PLANNING BOARD AGENDA JULY 26, 2023-7:00 P.M.

Re: 728 Route 6 TM 76.22-1-54

response to memo

RE: Diamond Point Development 4 Baldwin Place Road Town of Carmel TM#'s: 86.10-1-2&3

Sketch Layouts

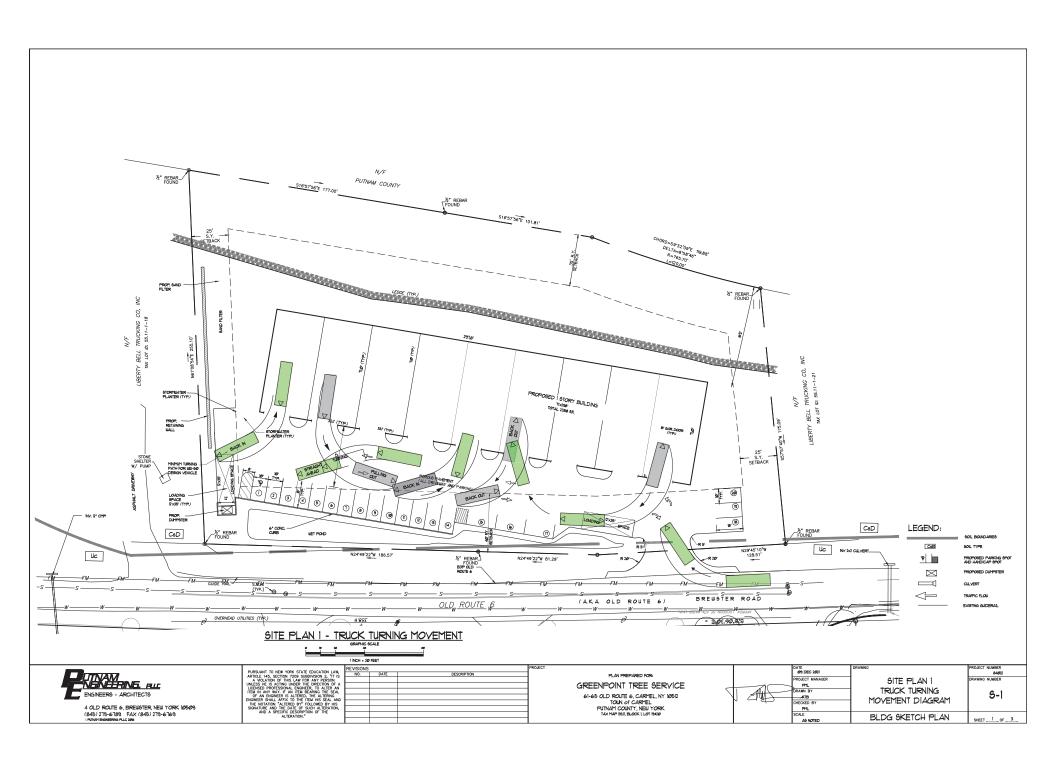
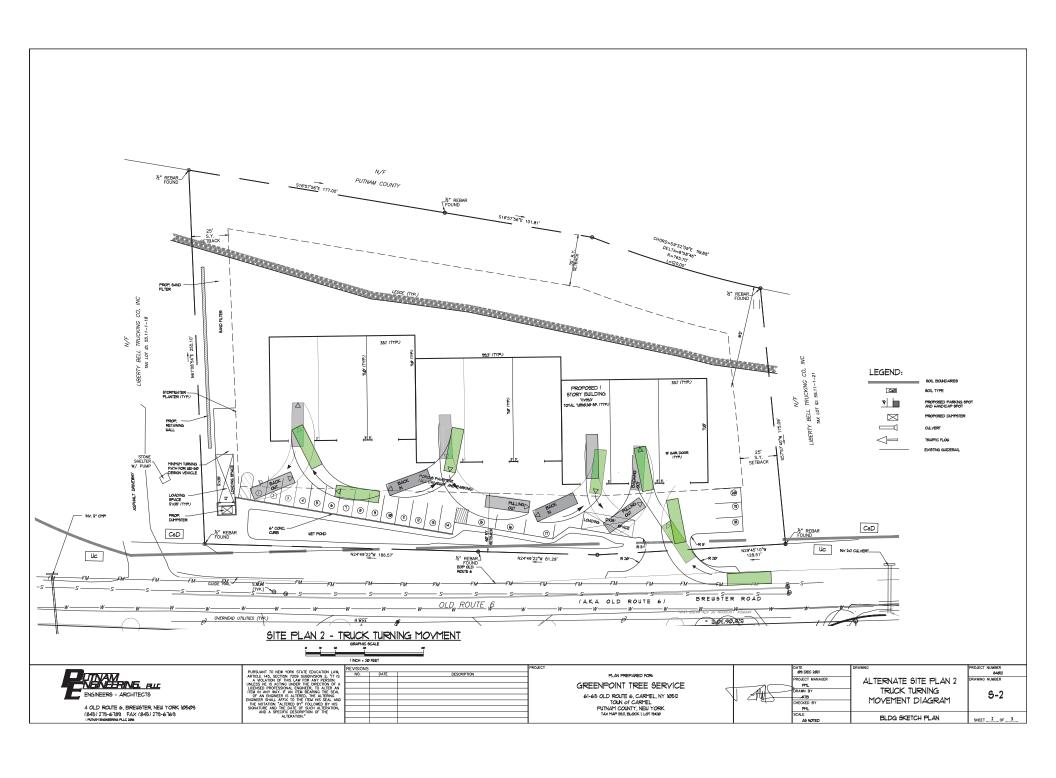
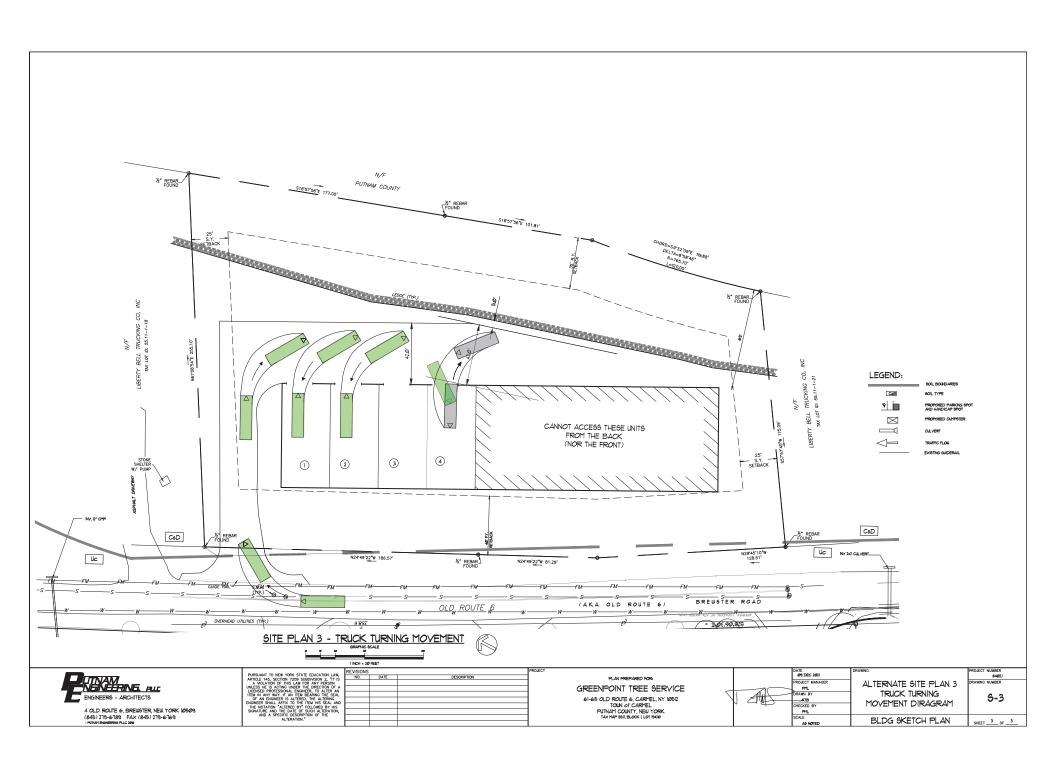
This property first appeared before the Board on October 26, 2022. At that meeting the Board expressed concerns about the orientation of the building with it being on an angle from Old Route 6 and having forty two (42) feet of open pavement area between the building and parking spaces that would be along the front property line. The concern I believe was that a general contractor renting out a unit in the complex could be tempted to place equipment outside and in front of their unit. In addition it was suggested that perhaps the entrance to the units be reversed and be placed on what would be the backside of the building thereby shielding the garage doors and open area from the road.

1. Original Submittal

2. Building Aligned with Street

3. Reversing the Garage Opening to Back Side of Building
